VARI*LITE TECHNICAL BULLETIN

SUBJECT: VLX3 Wash LED Luminaire Software Release	SERIES: VLX3 Wash
DISTRIBUTION: Service Centers, End Users	STATUS: Routine

Menu Operational Chart for New-Style VLX3 Wash Luminaire MCB
 The operational menu chart is for new-style MCBs only. For current (or old-style) MCB operational menu settings, refer to the user's manual.

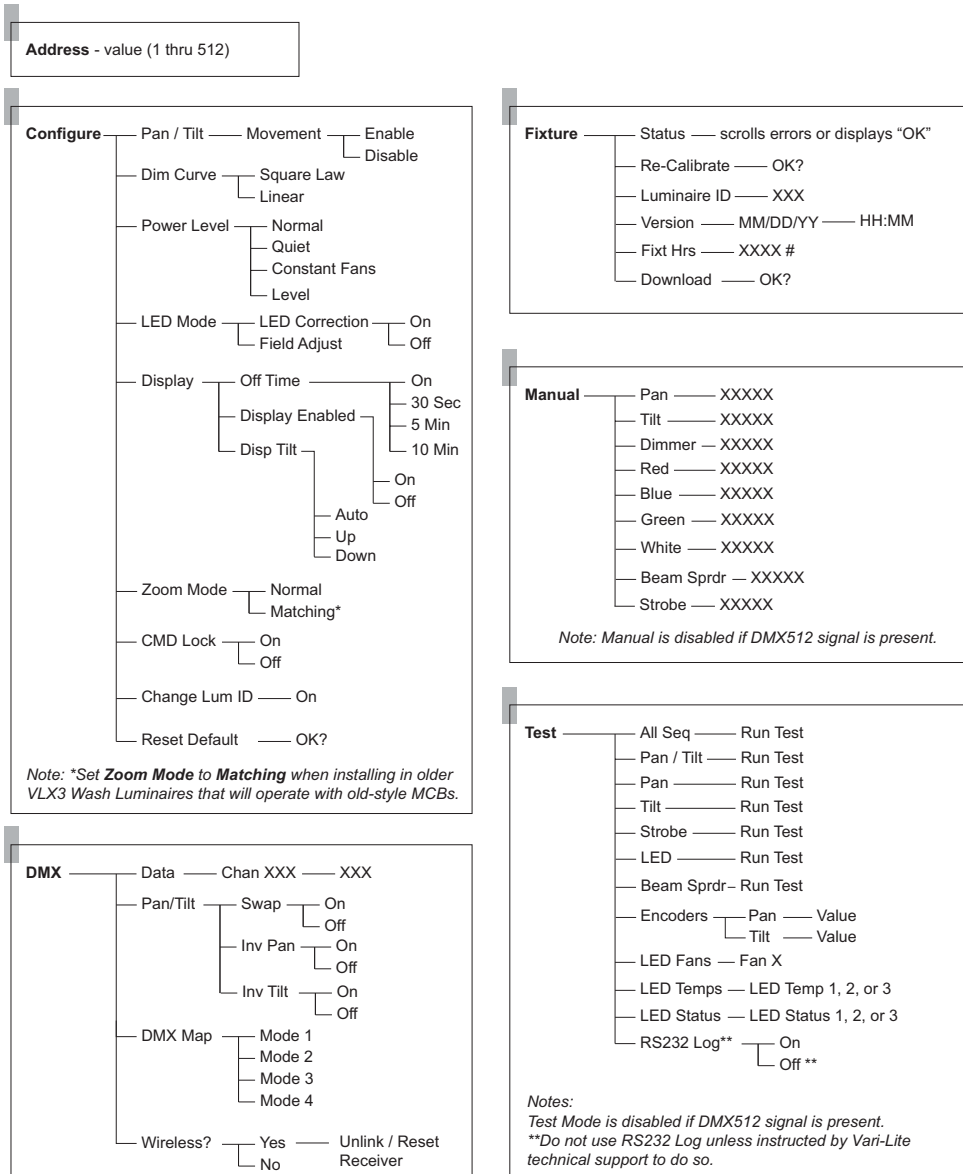
- This software is an update of **05/10/12** and is completely compatible with all VLX3 Wash Luminaire Main Control Boards (MCBs). It incorporates all features and menu structure of software version **05/10/12**. Only a few, non-user changes have been made to this version of software.
- Version **05/10/12** is removed from the Vari-Lite web site and is no longer available for download. Users are encouraged to update their VLX3 Wash LED Luminaires with this new version of software.
- New-style MCBs (on luminaires built after **05/18/12**) must have this software version (or later) installed or zoom mechanism will not function. A matching zoom feature* is added for new-style MCBs to match the speed and performance of old-style MCBs. See “[Menu Operational Chart for New-Style VLX3 Wash Luminaire MCB](#)” on page 2 of this bulletin for and updated menu structure.

Note: * This feature should be used when using a mixture of luminaires with old-style and new-style MCBs.

IMPORTANT! When using the new-style MCB, you must have luminaire software VLX3_051012.bin or later installed or zoom will not function. Users that have downloaded and installed software version **05/10/12** upgrade their fixtures to software version **05/30/12**.
